PROPOSED AMENDMENT No. 184
FACILITY OPERATING LICENSE NO. NPF-14
SUSQUEHANNA STEAM ELECTRIC STATION
UNIT NO. 1

**PROPOSED AMENDMENT No. 140
FACILITY OPERATING LICENSE NO. NPF-22
SUSQUEHANNA STEAM ELECTRIC STATION
UNIT NO. 2**

SAFETY ASSESSMENT

MODIFY THE REACTOR COOLANT pH ANALYSIS REQUIREMENT

Figure 2
CONDUCTIVITY, pH, AND CHLORIDE
CONCENTRATION OF AQUEOUS SOLUTIONS
AT 77°F (25°C)

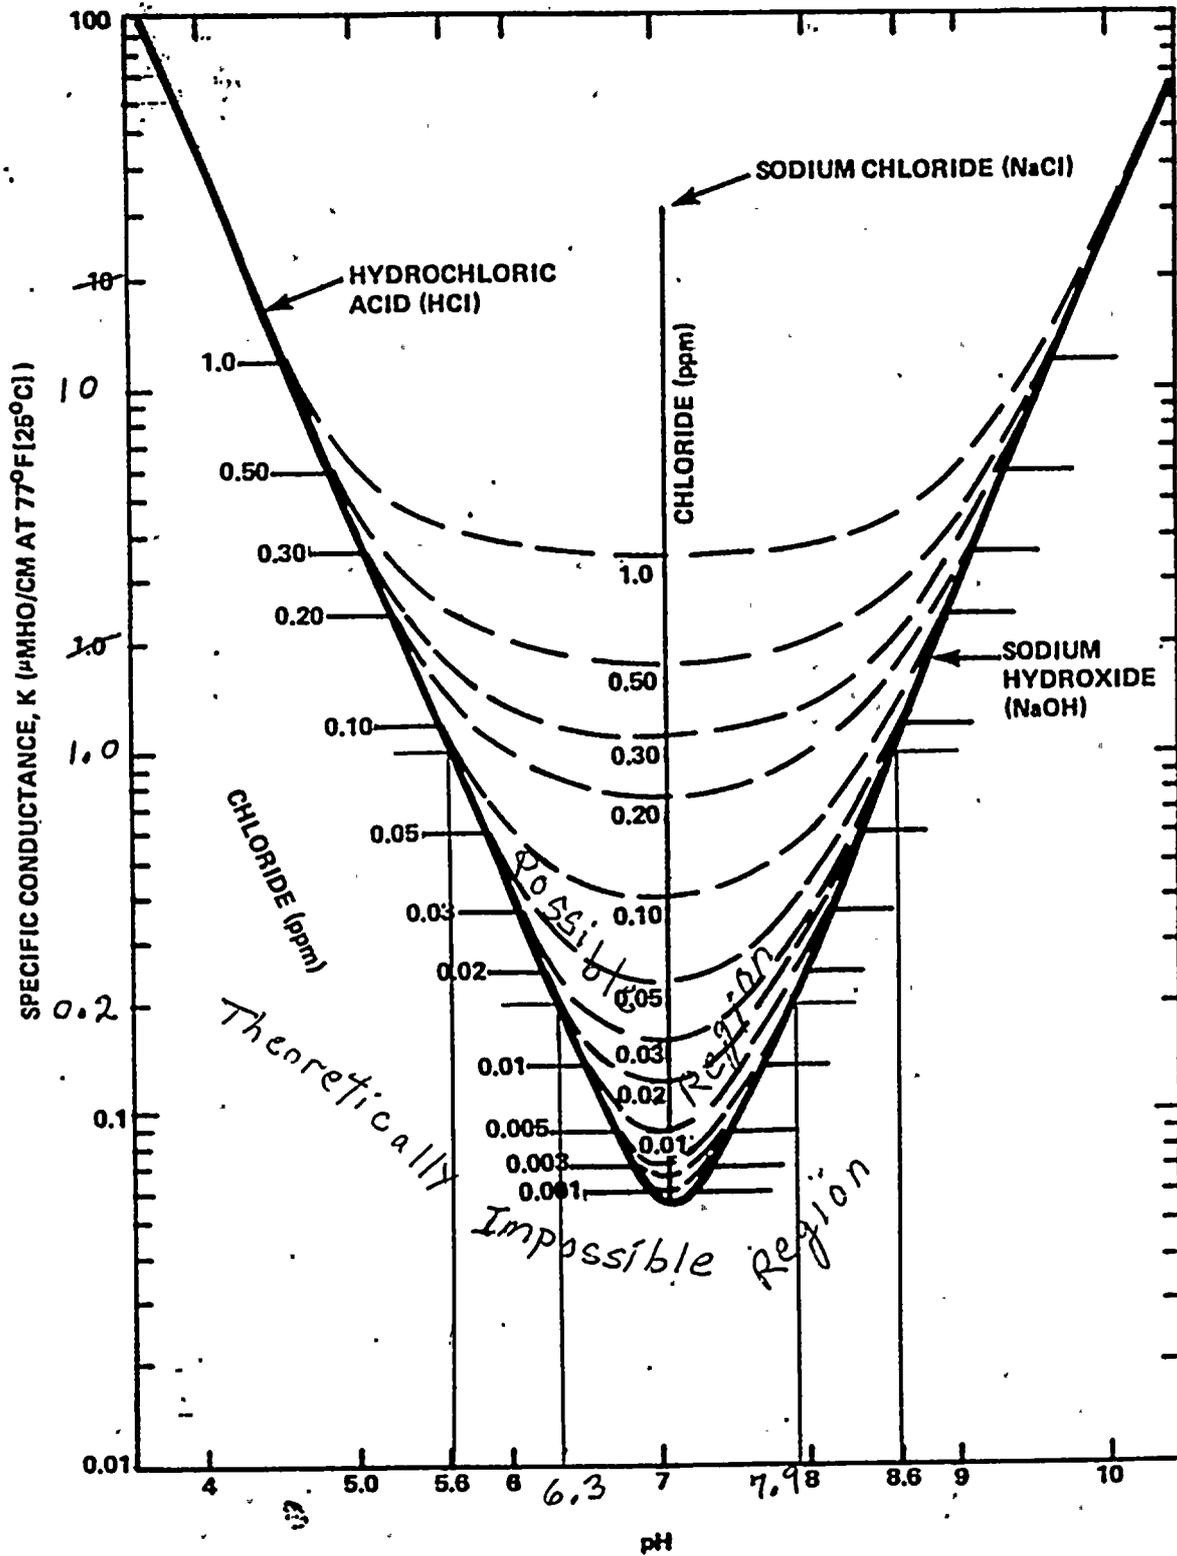
The theoretical relationship between pH and conductivity is shown in Attachment A. This figure is from Regulatory Guide 1.56 Revision 1, July 1978, "Maintenance of Water Purity in Boiling Water Reactors". The solid curve indicates the dividing line between regions where the theoretical relationship between pH and conductivity is possible and where it is impossible. (The dashed lines are related to chloride concentrations and can be ignored in this discussion.) For example, if the conductivity is 0.2 $\mu\text{mho/cm}$, the pH may be anywhere in the range from 6.3 to 7.9 but it can never be less than 6.3 nor greater than 7.9. Likewise, if the conductivity is 1.0 the pH must be in the range from 5.6 to 8.6. Obtaining reliable pH measurements for high purity water is very difficult if not impossible using current standard methods. The normal calibration procedure for pH electrodes using pH buffers will not yield correct pH measurements in water with a conductivity below 1.0 $\mu\text{mho/cm}$. This is an inherent limitation of the standard electrodes used in pH measuring equipment. In addition to this problem, laboratory pH measurements on grab samples of high purity water are subject to large errors due to the absorption of carbon dioxide from the atmosphere while sampling, transporting and waiting for the pH meter readings to stabilize. The combination of these two problems has resulted in the reporting of pH values for reactor coolant that are in the impossible region; generally, the measured pH values reported are lower than theoretically possible for the measured in-line conductivity.
